ARCHITECTURAL REVIEW BOARD WORK SESSION AGENDA

Agenda Item: Architectural Review for DP#25-01, 535 Herndon Parkway

Subject: Architectural Review for DP #25-01, 535 Herndon Parkway

Subject: Discussion Item, proposed Special Exception (SE#25-02), 250 Spring Street

NE CORNER

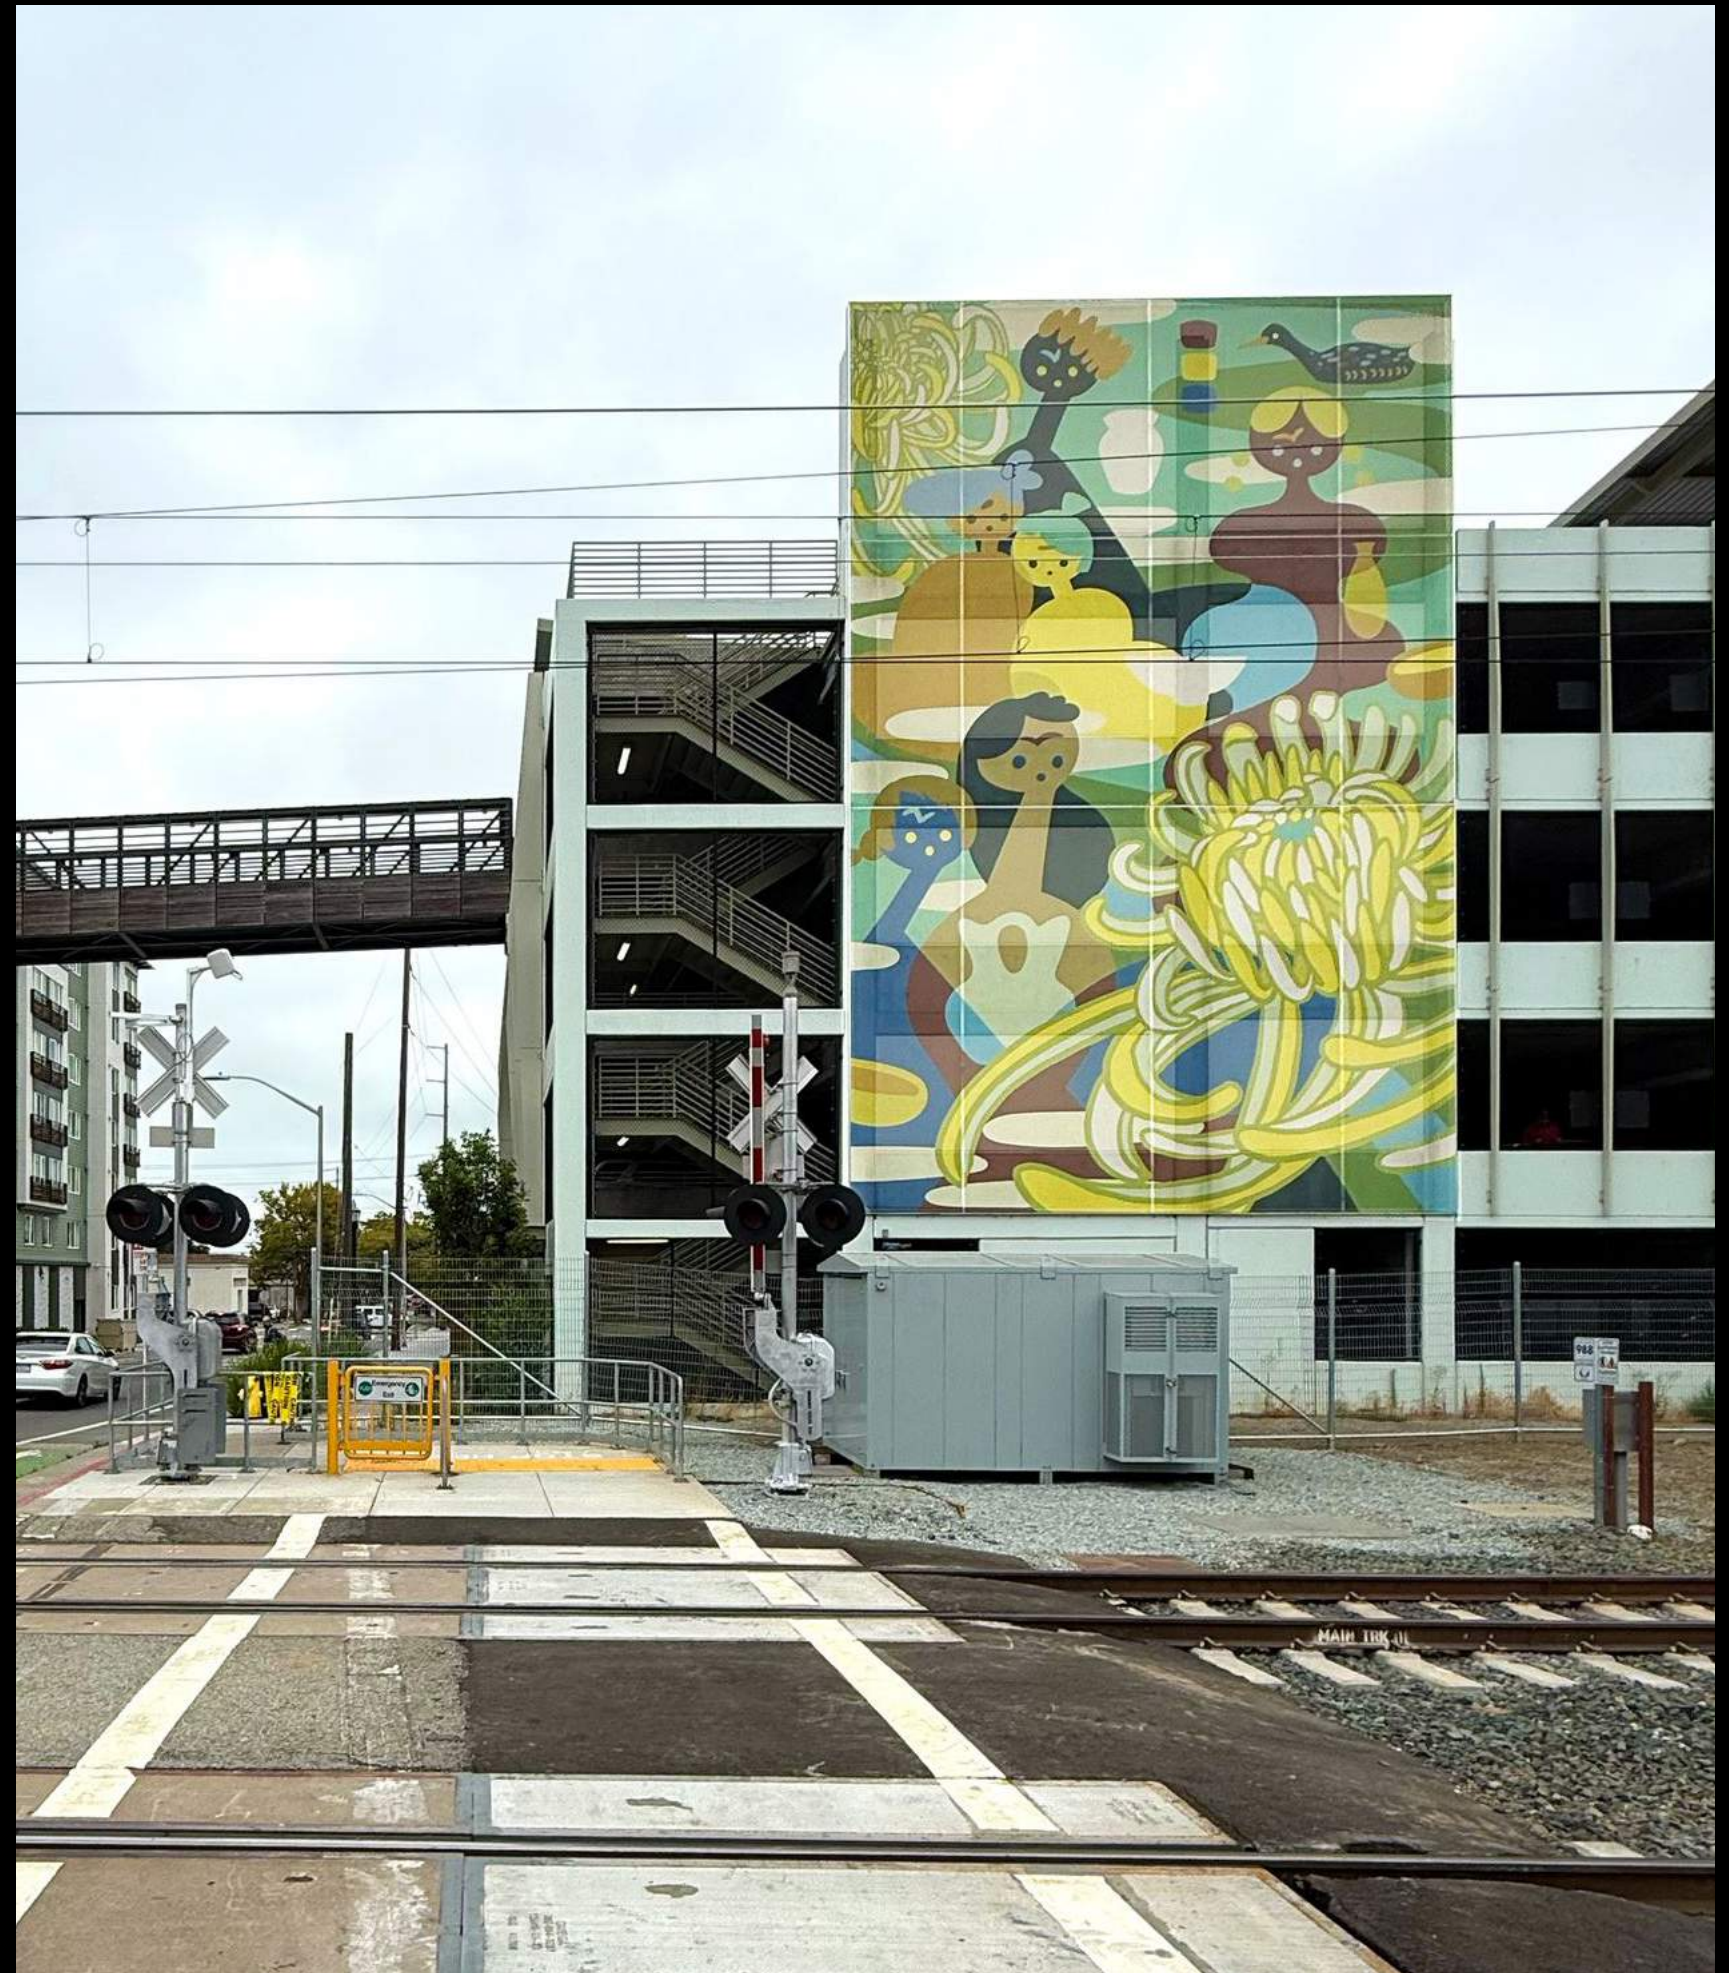
comprised of individual architectural expressions that give the impression of a collection of smaller buildings across the block. Bays can be better articulated by stepping back the facade to create shadow lines across the elevation. This is achieved somewhat along the west elevation, with the use of plane changes both vertically and horizontally across the façade, however, this technique should be employed more extensively throughout the design.

The current building has both massing and scale issues that can be resolved by using this design approach. For example, the southwest corner of the building should be pulled back to create open area to accommodate possible amenity space or a focal feature. This might be achieved by chamfering the concrete podium and cantilevering the upper floors, though other architectural solutions may work to create a better pedestrian environment at this corner. Furthermore, ground level retail, such as that found on the northeast corner, should use the full podium height.

Building Cladding and Façade Articulation: Although the submission package does not include material callouts for the building cladding, the renderings give the appearance of an over-reliance on fiber-cement paneling and lap siding. This has a flattening effect and diminishes the ability of the design to read as a cluster of smaller buildings vertically across each elevation as recommended by the HTOC Design Guidelines (p. 32). Using a more varied material palette with a larger selection of textures will help to better articulate individual bays along each elevation.

Varied Roofline and Cornice Detailing: The roofline of the north and south elevations is monotonous and creates a monolithic feeling from the street. Roofline heights and designs should be varied in these areas to obviate this effect, in accordance with the HTOC Design Guidelines (p. 34).

mitigated through varying design elements such as cladding, fenestration, and cornice details. There is currently a thick cornice on the northeast and southwest corners of the building and similar detailing should be employed in other areas of the design. The applicant should provide a rendering or section that illustrates the depth and overall appearance of the cornice feature. Staff have included an example of a well-articulated cornice below (*Figure 2*).

Figure 5: Examples of other ExtraSpace Storage facility designs with masonry cladding and detailing. Left: 1046 Richard D Sailors Pkwy, Powder Springs, GA; Right: 3805 Powder Springs Rd, Powder Springs, GA.

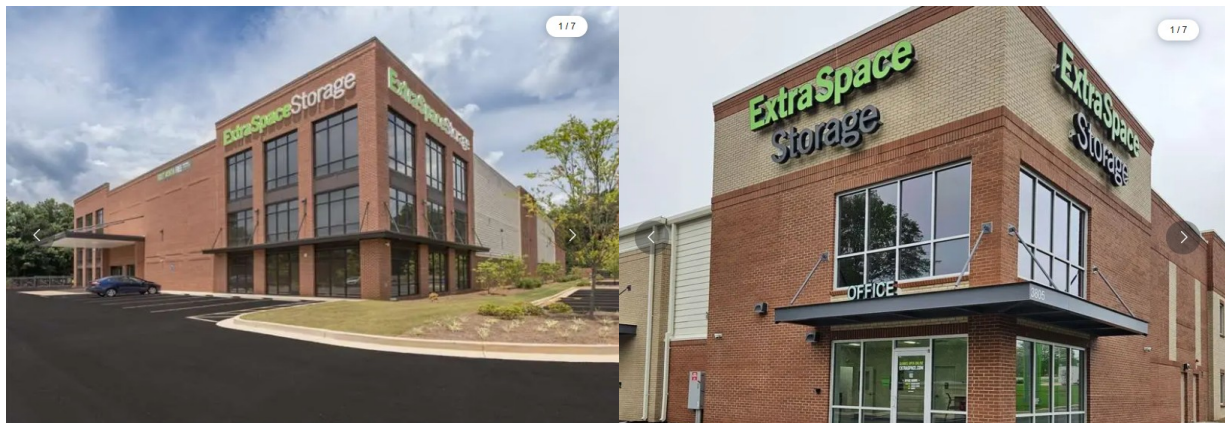
Conformance to Accepted Architectural Principles (Criterion 5): The proposed design is largely consistent with the massing and overall façade articulation and hierarchy of other ExtraSpace Storage designs that employ brick on the façade (*Figure 5*). However, the articulation of the fenestration appears to be better resolved in the finished examples from elsewhere than it is depicted in the renderings for the proposed design at 250 Spring Street, particularly as seen on the façade (south elevation). The ARB should discuss expectations for appropriate detailing and overall articulation for the fenestration of the proposed design.
